Parkland Addition Replat E

City of El Paso — City Plan Commission — 2/8/2018

SUSU18-00007 — Resubdivision Combination

SUMMARY OF REQUEST: The applicant proposes to resubdivide 2.7548 acres into one lot. The purpose of the replat is to create one lot from two existing parcels. Access to the subdivision is from Dyer Street and Pheasant Road. This development is being reviewed under the current subdivision code.

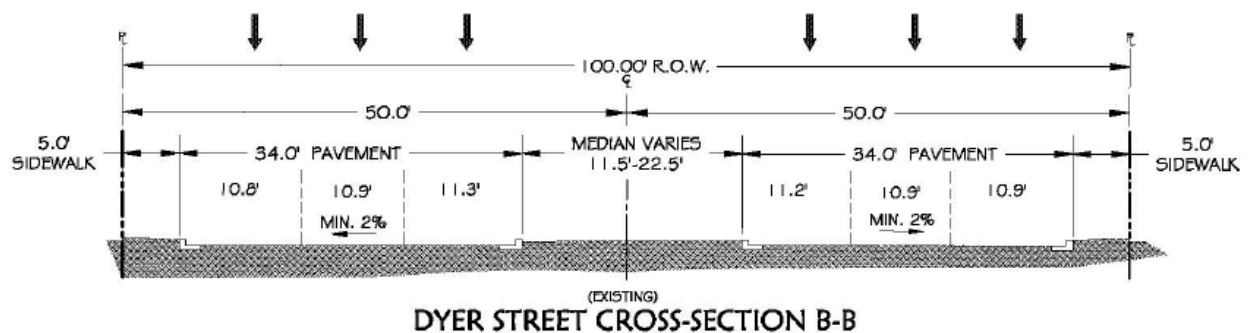
DESCRIPTION OF ANY EXCEPTIONS, MODIFICATIONS, OR WAIVERS

- To waive a 5' landscape parkway along Dyer Street.
 - Currently, there is no landscape parkway.

The applicant does not meet the criteria under Section 19.10.050 (Roadway participation policies – Improvement of roads and utilities within and or abutting the subdivision) for requesting exceptions. The section reads as follows:

The subject property is located on TxDOT right-of-way.

ATTACHMENT 1

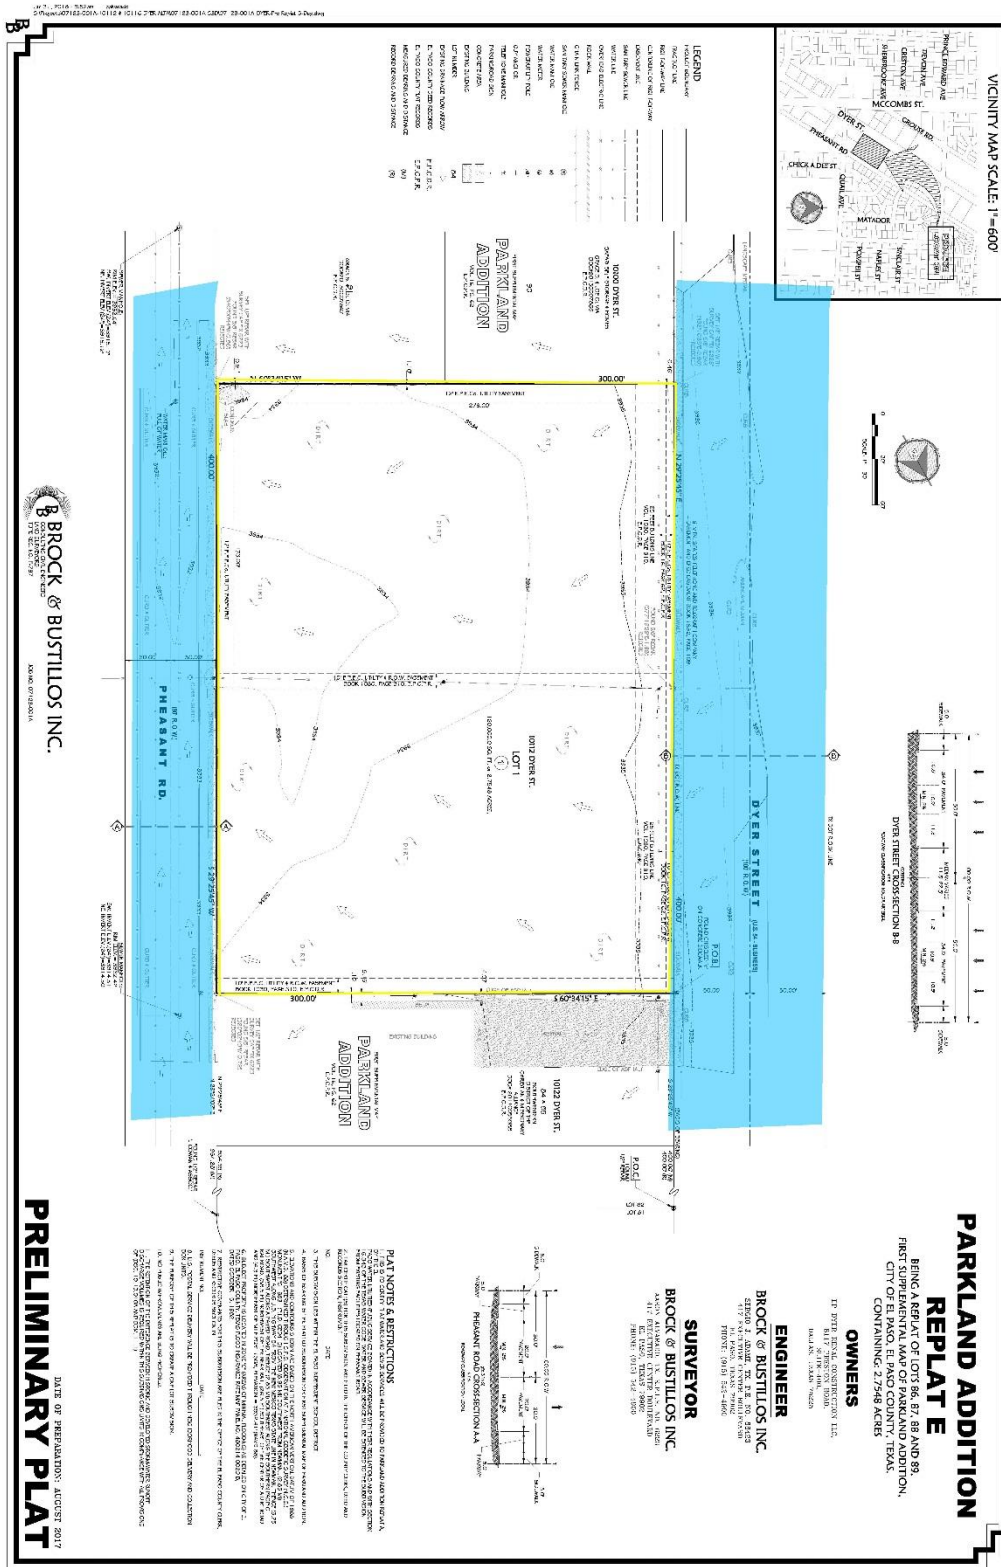
Change to Block 1, Lot 1
